Intel[®] IXP43X Product Line of Network Processors

Specification Update

December 2008

Order Number: 316847; Revision: 005US

13. Ethernet MACs Detect Late Collision Earlier Than Ethernet 802.3 Specifications

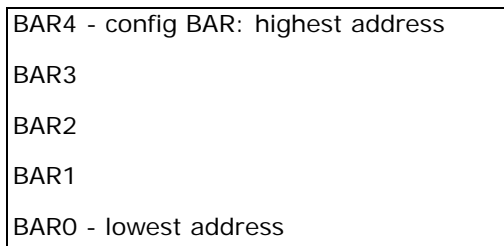
Problem: On an improperly designed network, when a collision occurs on the threshold of the smallest valid Ethernet frame, it is detected as a late collision rather than an early collision.

Implication: The collided frame will not be retried up to the programmed retry count and will be dropped.

Workaround: Cable lengths, number of repeaters, and other parameters that affect the network design must be planned not to operate on the boundary of the Ethernet specifications.
